## **RESOLUTION MEPC.141(54)**

### **AMENDMENTS TO THE ANNEX OF THE PROTOCOL OF 1978 RELATING TO THE INTERNATIONAL CONVENTION FOR THE PREVENTION OF POLLUTION FROM SHIPS, 1973**

#### **(Amendments to regulation 1, addition to regulation 12A, consequential amendments to the IOPP Certificate and amendments to regulation 21 of the revised Annex I of MARPOL 73/78)**

Figure 1 - Oil fuel tank boundary lines for the purpose of paragraph 6

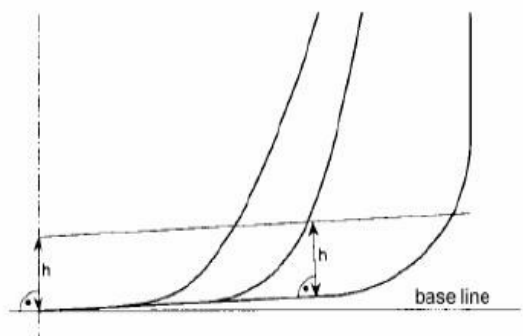
6 For ships, other than self-elevating drilling units, having an aggregate oil fuel capacity of 600 m<sup>3</sup> and above, oil fuel tanks shall be located above the moulded line of the bottom shell plating nowhere less than the distance  $h$  as specified below:

$$h = B/20 \text{ m or,}$$

$$h = 2.0 \text{ m, whichever is the lesser.}$$

The minimum value of  $h = 0.76 \text{ m}$

In the turn of the bilge area and at locations without a clearly defined turn of the bilge, the oil fuel tank boundary line shall run parallel to the line of the midship flat bottom as shown in Figure 1.

Figure 2 - Oil fuel tank boundary lines for the purpose of paragraphs 7 and 8

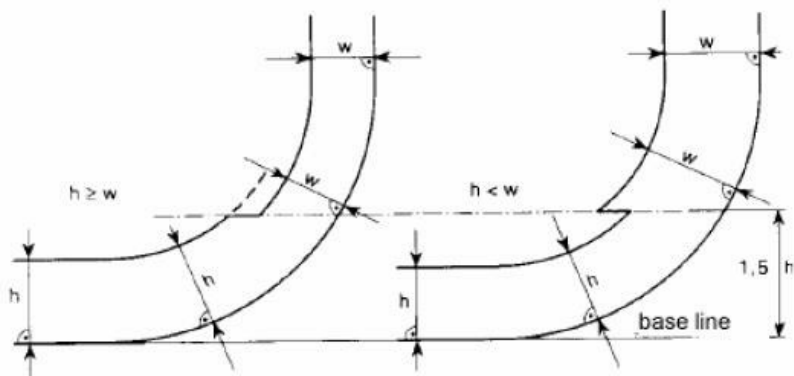
7 For ships having an aggregate oil fuel capacity of 600 m<sup>3</sup> or more but less than 5,000 m<sup>3</sup>, oil fuel tanks shall be located inboard of the moulded line of the side shell plating, nowhere less than the distance  $w$  which, as shown in Figure 2, is measured at any cross-section at right angles to the side shell, as specified below:

$$w = 0.4 + 2.4 C/20,000 \text{ m}$$

The minimum value of  $w = 1.0 \text{ m}$ , however for individual tanks with an oil fuel capacity of less than 500 m<sup>3</sup> the minimum value is 0.76 m.

8 For ships having an aggregate oil fuel capacity of 5,000 m<sup>3</sup> and over, oil fuel tanks shall be located inboard of the moulded line of the side shell plating, nowhere less than the distance  $w$  which, as shown in Figure 2, is measured at any cross-section at right angles to the side shell, as specified below:

$$w = 0.5 + C/20,000 \text{ m or}$$

$$w = 2.0 \text{ m, whichever is the lesser.}$$

The minimum value of  $w = 1.0 \text{ m}$

Figure 3 - Dimensions for calculation of the minimum oil outflow for the purpose of subparagraph 11.5.3.3

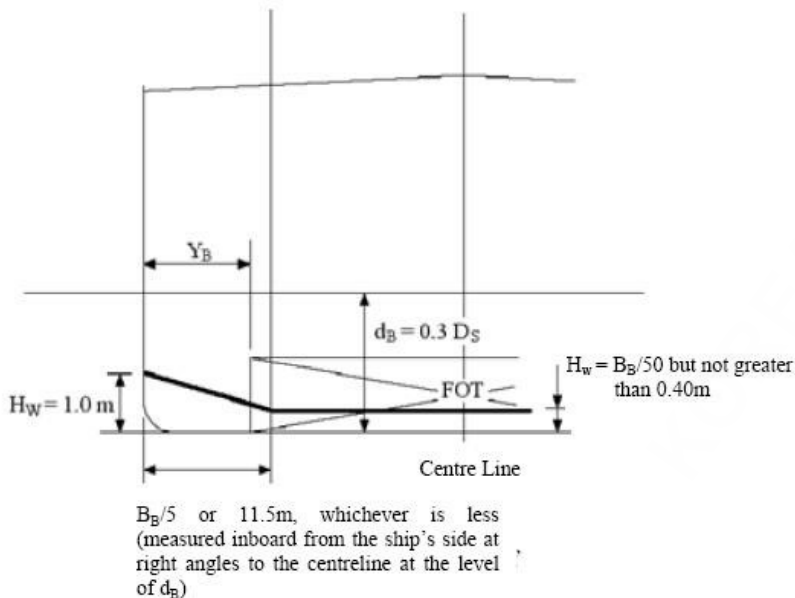
.3 The oil outflow OB(i) for any tank bounding the bottom shell plating shall be taken not less than the following formula, but no more than the tank capacity:

$$OB(i) = HW \cdot A$$

$$HW = 1.0 \text{ m, when } YB = 0$$

$$HW = BB/50 \text{ but not greater than } 0.4 \text{ m, when } YB \text{ is greater than } BB/50 \text{ or } 11.5 \text{ m, whichever is less}$$

"HW" is to be measured upwards from the midship flat bottom line. In the turn of the bilge area and at locations without a clearly defined turn of the bilge, HW is to be measured from a line parallel to the midship flat bottom, as shown for distance "h" in Figure 1.

For YB values outboard BB/50 or 11.5 m, whichever is less, HW is to be linearly interpolated.

YB = the minimum value of YB over the length of the oil fuel tank, where at any given location, YB is the transverse distance between the side shell at waterline dB and the tank at or below waterline dB.

A = the maximum horizontal projected area of the oil fuel tank up to the level of HW from the bottom of the tank.
